RESEARCH PLAZA

SOUTH ABILENE STREET AND EAST FLORIDA AVENUE
AURORA, COLORADO

LANDSCAPE PLAN

REVISED LANDSCAPE PLAN
FOR
PACIFICA ARKA
I-225 PLAZA
S. ABILENE ST. & S. FLORIDA AVE.
AURORA, COLORADO

LANDSCAPE PLAN

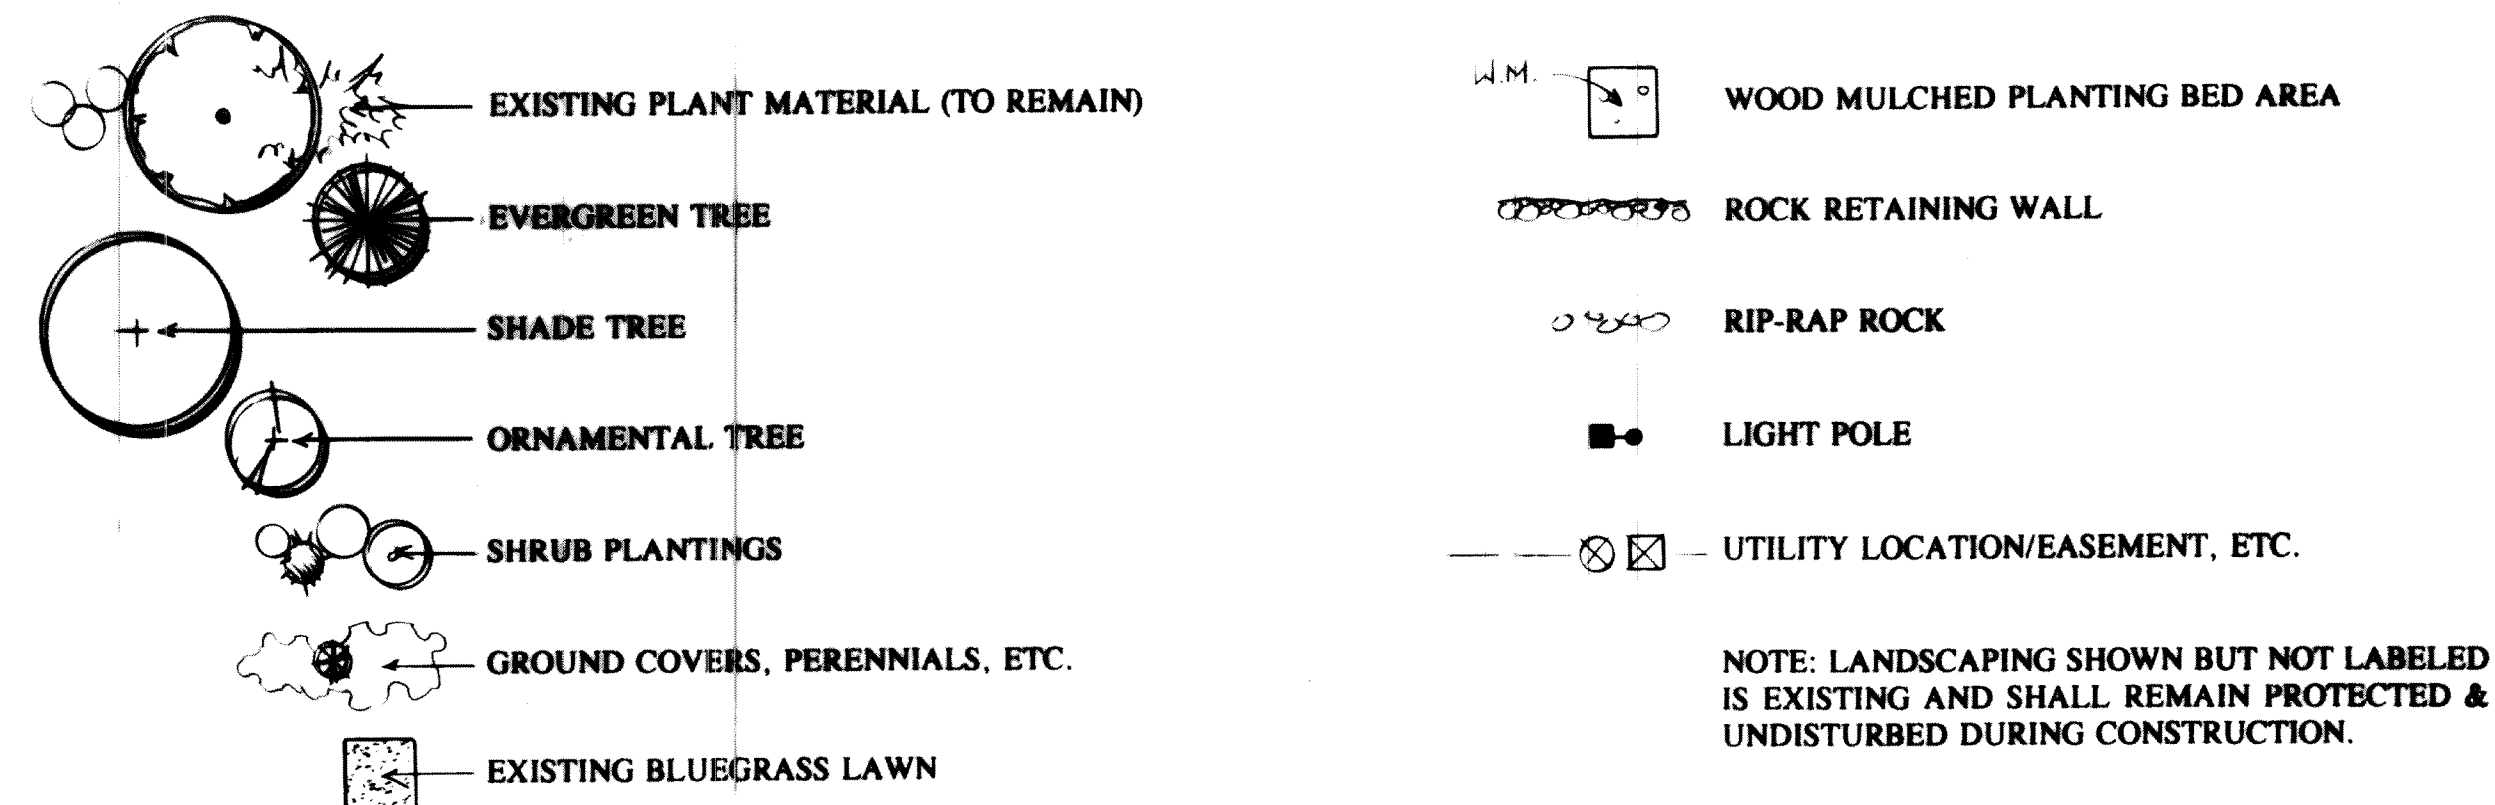
ADMIN. AMEND. 6-11-05
DELETE WALK
